**Re: El Parador Multi-Family Development  
201 Yale Blvd SE  
Traffic Circulation Layout  
Architect's Stamp 01-28-2022 (K15-D107)**

The TCL submittal received 02-07-2022 is approved for Building Permit with. A copy of the stamped and signed plan will be needed for each of the building permit plans. Please keep the original to be used for certification of the site for final C.O. for Transportation.

TRAFFIC CIRCULATION LAYOUT  
APPROVED

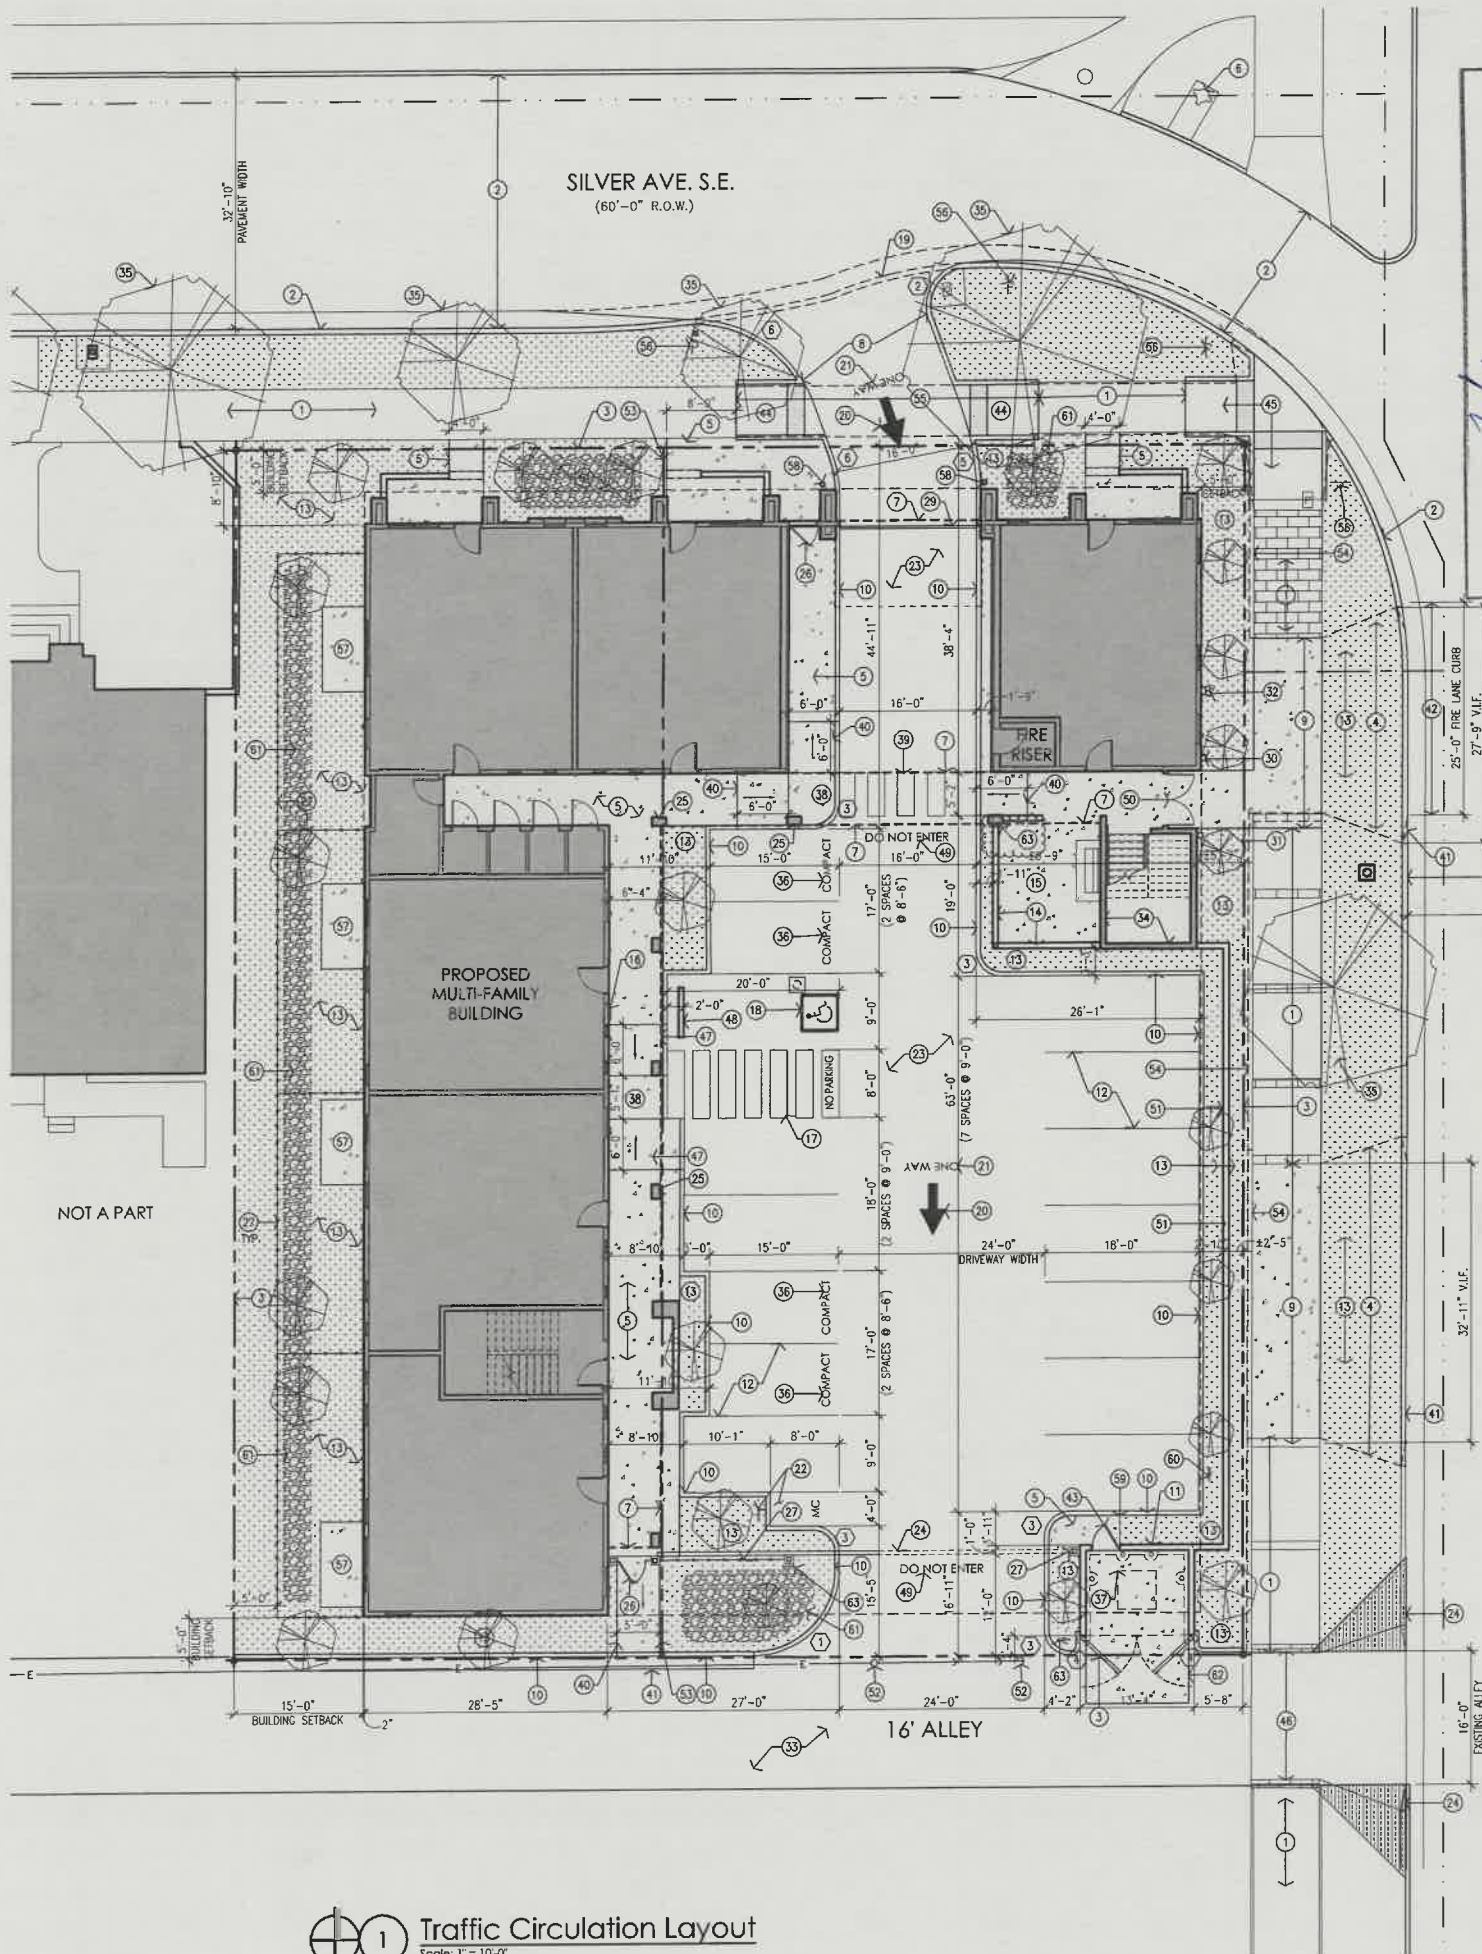
ALL WHEELCHAIR RAMPS LOCATED  
WITHIN THE PUBLIC RIGHT OF WAY  
SHOULD HAVE TRUNCATED DOMES.
